RECEIPT DATE: 6/22/18 **ONSITE SEWAGE DISPOSAL SYSTEM** P 563033

APPROVAL DATE: 11/21/18 sec **PERMIT:** REPAIR A

PROPERTY ADDRESS: 4376 Route 97

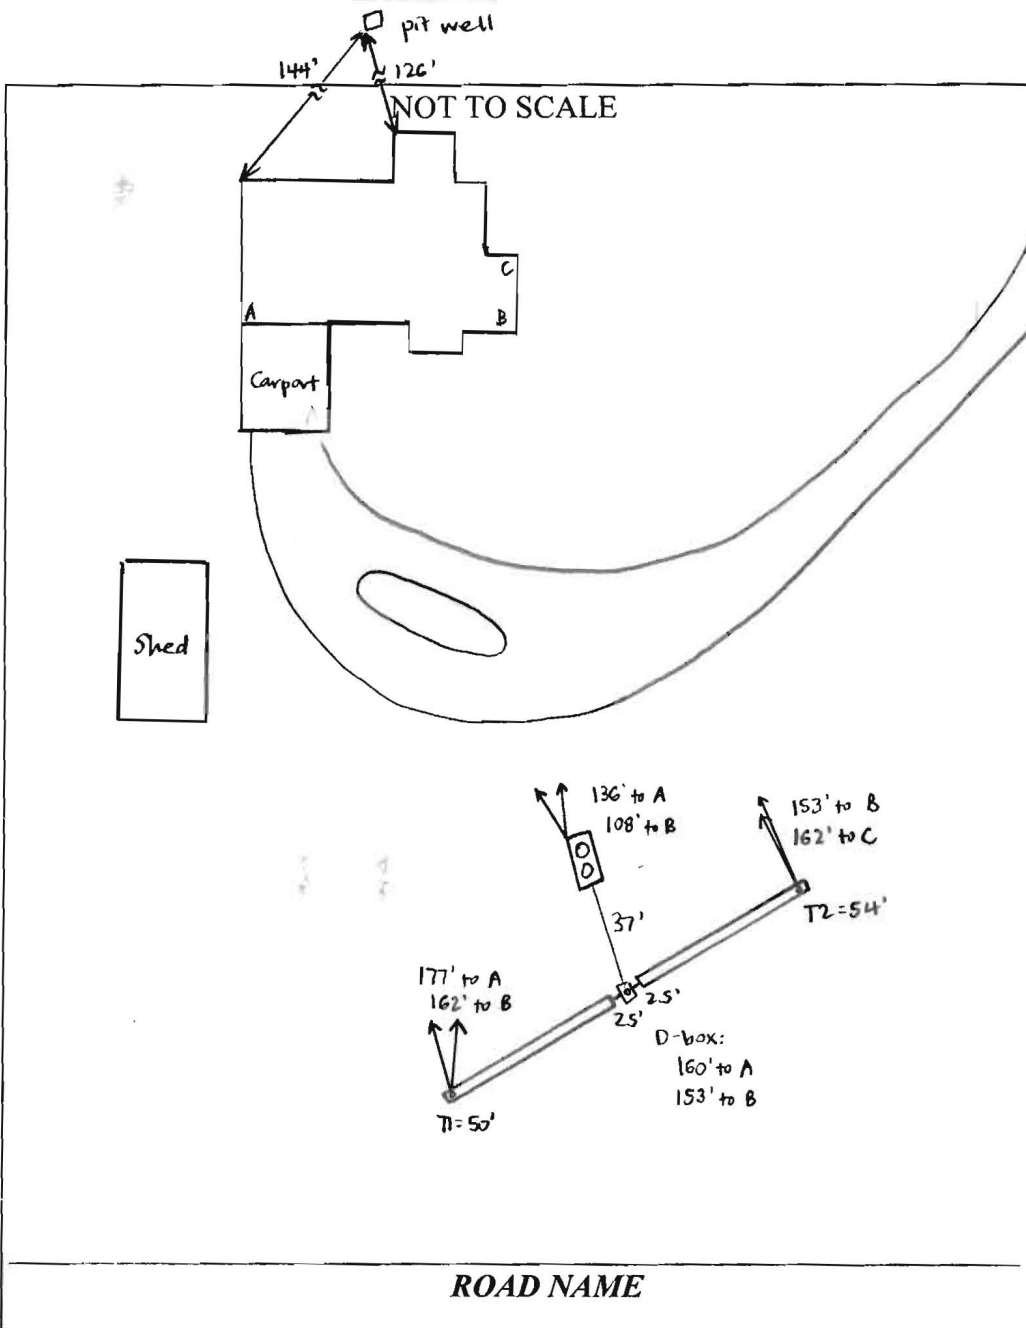
NOTES: Install new S.T. below ex. S.T. If pipes are clear (no roots) OK to fire plumbing back in to ex trenches.
If new trenches needed. Install Dbox w/ 205' turbs in both directions below ex. manhole. Painted/Flagged in field.

INSTALLATION: 11/19/18 New tank and trenches installed. Contractor not on site, says old tank was pumped + removed. Inlet end of tank currently has 4'+ of fill, contractor will take down to 3.5' cover at inlet, 3' cover at outlet. Observation pipes in trenches need screw caps - notified contractor. Pipes out of D-box are sealed w/ roofing tar. Need speed levelers in D-box. [Corrective action.] Trenches 2' wide, 2.5-3' to stone. (SC)

11/21/18 Contractor sent pictures of speed levelers in D-box. [Corrective action completed.] (SC)
